Technical Service Bulletin

SUBJECT: Transaxle/Drive Motor Upgrade. More Robust, Increased reliability, Lower dBA level, less Amp draw, Better ramp climbing.

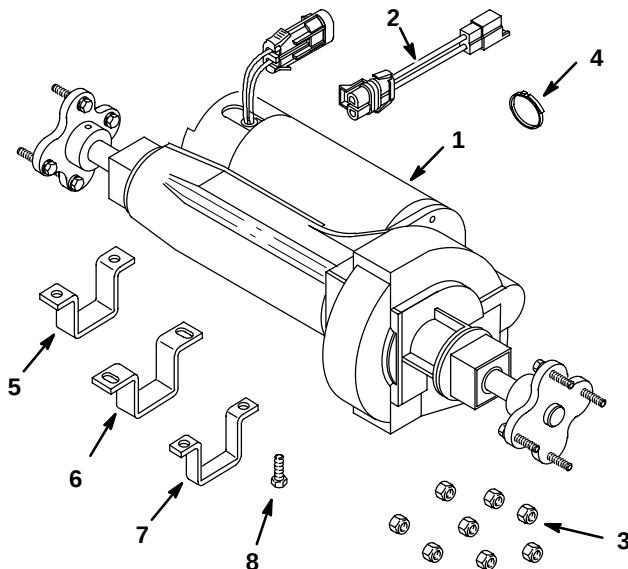
NEW STYLE

OLD STYLE-Discontinued
630126-24V / 603450-36V

24V TRANSAXLE REPLACEMENT KIT CONTENTS #613160 (24V)
